Limerick Generating Station, Units 1 & 2
Facility Operating License Nos. NPF-39 and NPF-85
NRC Docket Nos. 50-352 and 50-353

Subject: Supplement to the Request for License Amendment Related to
Application of Alternative Source Term, dated February 27, 2004

Response to Request for Additional Information

JOB NO.	DRAWING NO.	REV.
8031	M - 107	2

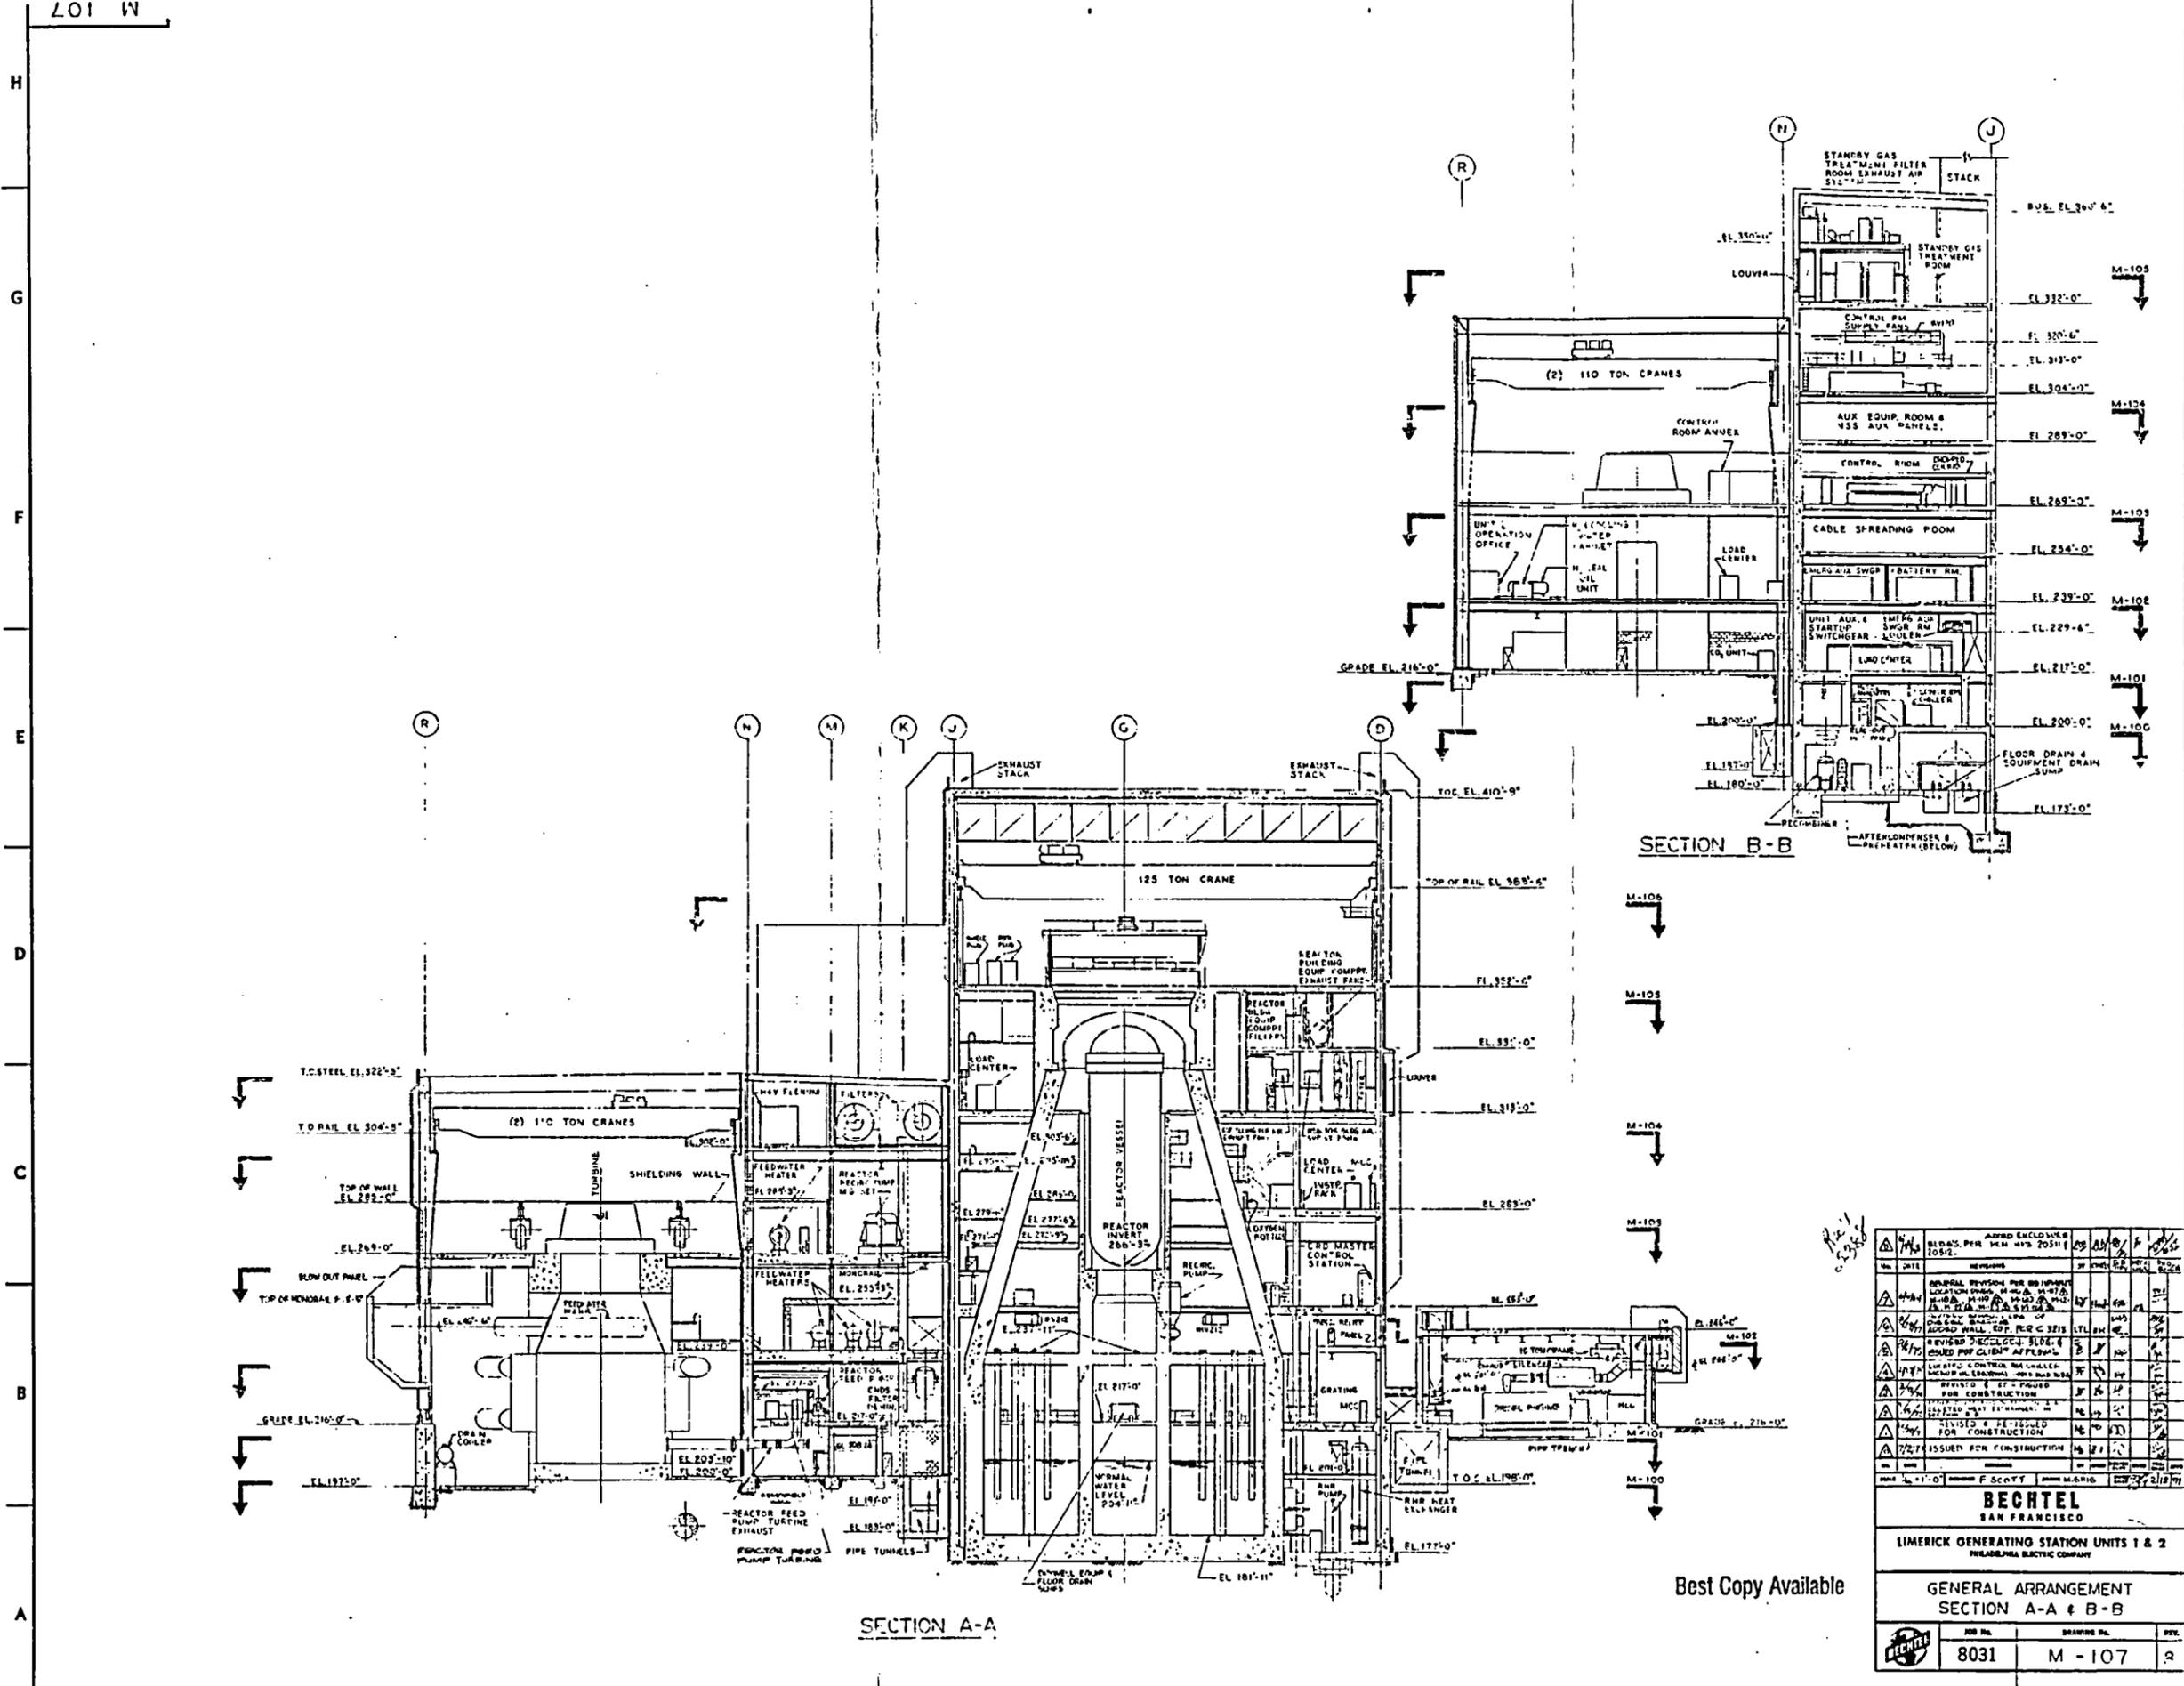
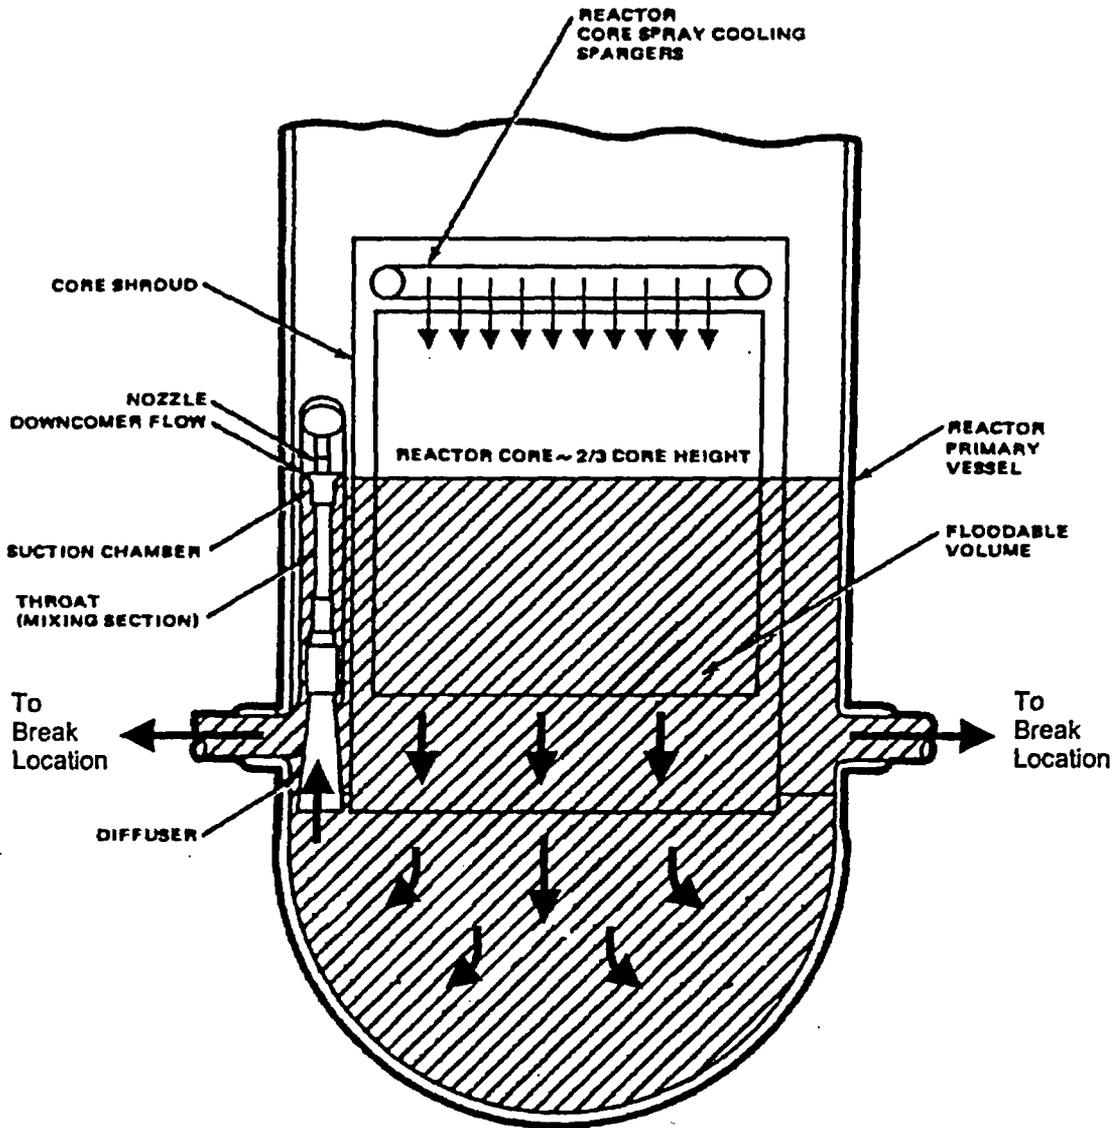
23. The proposed change to TS 3.6.5.1.2, "Refueling Area Secondary Containment Integrity," will no longer require that the secondary containment be operable during the movement of fuel assemblies that have a decay period of at least 24 hours. The fuel-handling accident (FHA) analysis assumes the release to the control room intake and the environment is through the turbine building/reactor building (TB/RB) ventilation south stack. Please justify that an FHA release through the TB/RB ventilation south stack is an appropriately conservative assumption given that the secondary containment may be inoperable. Include general arrangement drawings in your response showing the potential release points.

Site walkdowns and specific reviews of the LGS General Arrangement Drawings such as M-102, the Plan at El. 217' - 0" (one foot above Grade) and M-107, the Section showing the North and South Stack, confirmed that there are no potential release pathways that could be worse with respect to the Control Room intake than the analyzed stacks (these drawings are included in Attachment 4).
